BELL SYSTEM PRACTICES
Station Installation and Maintenance

ADDENDUM C32.505
Issue 1, 5-31-46
AT&T Co Provisional

TELEPHONE SETS

NORTH ELECTRIC

Fig. 1

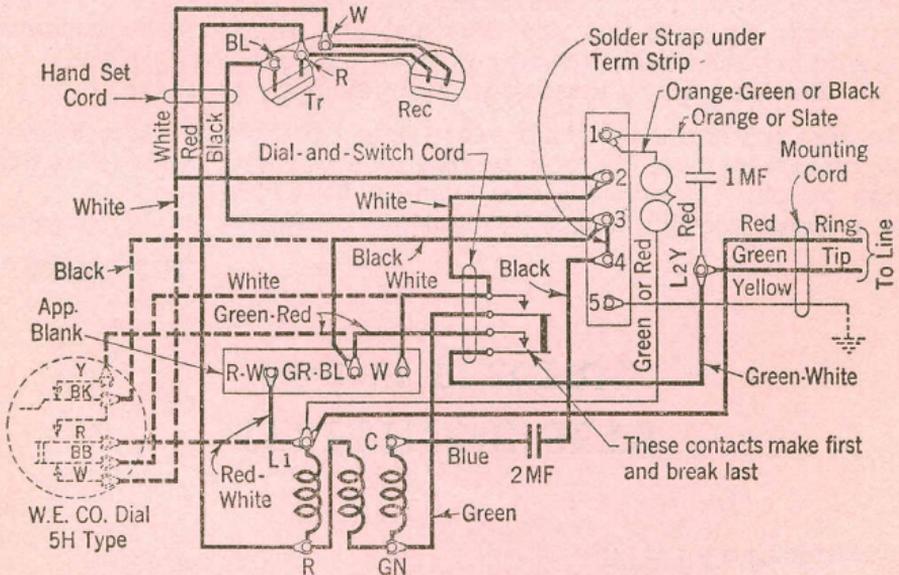
3.01 The connections for North Electric telephone sets are shown in Fig. 1 herein which replaces Fig. 1 of the section. The new connections should be provided for all new installations, reinstallations and additions of dials to the sets. Likewise whenever customer complaints of dial or switch clicks

at existing installations are received or repairs are made which require reconnections at set terminals, such as hand set, dial or cord replacements, the set connections should if necessary be changed to conform with those shown herein. These changes include the following:

- (1) Remove black condenser lead from L2Y of induction coil and connect it to Terminal 4 on terminal block.
- (2) Transfer green lead from L2Y to GN on induction coil.
- (3) Remove green-white lead from Terminal 3 of terminal block and connect it to L2Y of induction coil.
- (4) Remove black lead from L1 of induction coil and connect it to Terminal 3 on terminal block.
- (5) Transfer black conductor of hand set cord from Terminal 2 to Terminal 3 on terminal block.
- (6) Where a dial is added, transfer connections on apparatus blank to dial.

Note: If the free length of the white conductor of the hand set cord is too short to permit terminating this conductor at the W terminal of the dial, replace the cord with H3C-9 or equivalent cord.

New and repaired sets with the improved connections may be identified by the code 5H6SLD stamped on the underside of the base.
